RE: Comments on Public-Noticed Draft NPDES Permit (No. ID00000175) for Hecla Limited Lucky Friday Mine

RE: Comments on Public-Noticed Draft NPDES Permit (No. ID00000175) for Hecla Limited Lucky Friday Mine

RE: Comments on Public-Noticed Draft 401 Certification for the Draft Permit (No. ID00000175) for Hecla Limited Lucky Friday Mine

Figure 1. Stream Flow and Hardness Relationship

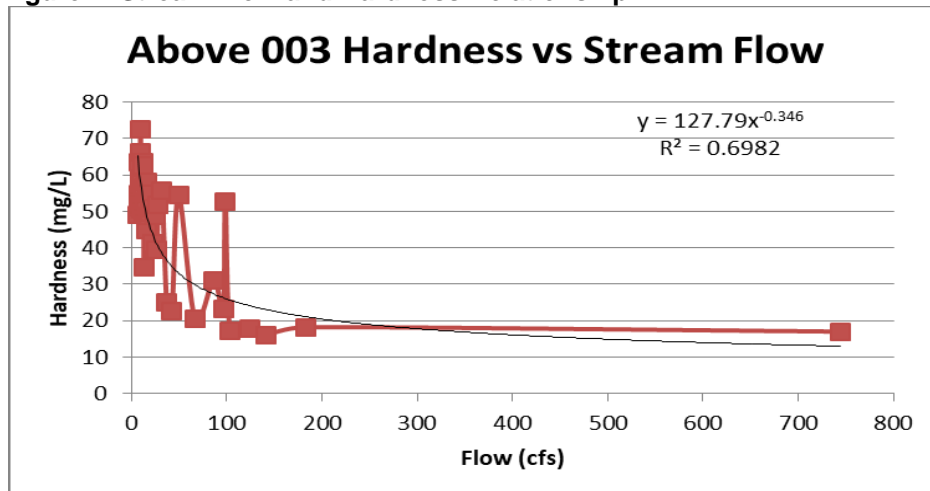
Comment #34, Appendix C.Part A(Page 69): As per the draft Fact Sheet, receiving stream hardness occurring at low flow conditions (i.e, 1Q10, 7Q10) was estimated based by plotting flow versus hardness data, collected upstream of Outfall 002 and 003 and is shown in Figures C-1 and C-2 of the Fact Sheet. As discussed in the *Idaho Mixing Zone Implementation Guidance*, use of such method is acceptable for estimating hardness at low flow for hardness-based metals criteria calculations. However, the statistical relation between hardness and flow should be determined by a nonlinear regression, as noted in the Guidance. While for Figure C-1 (Upstream of Outfall 002), low flow hardness was estimated from a regression using a polynominal trend line, a linear regression was used for Figure C-2, which was used to estimate the hardness of 49.8 mg/L at the 1Q10 and 49.7 mg/L at the 7Q10, for upstream of Outfall 003. The R² value for this linear regression is only 0.2897, which indicate low relationship between the trend line and actual data. LFU suggests that for estimating low flow hardness upstream of 003, a non-linear regression should be used. Using upstream hardness and corresponding river flows for Outfall 003, Figure 1 below presents a more appropriate analysis of the relationship. Using a power regression type provides for a much higher R² value, indicating a more realistic estimate of hardness at low flow. Using the information in Figure 1 below results in estimated low flow hardness of 81 mg/L at the 1Q10 flow of 3.7 cfs and 72 mg/L at the 7Q10 of 10.9 cfs (low flows as per Fact Sheet). Therefore, LFU requests the Figure C-2 be revised to utilize the more appropriate regression type and resulting estimated hardness.
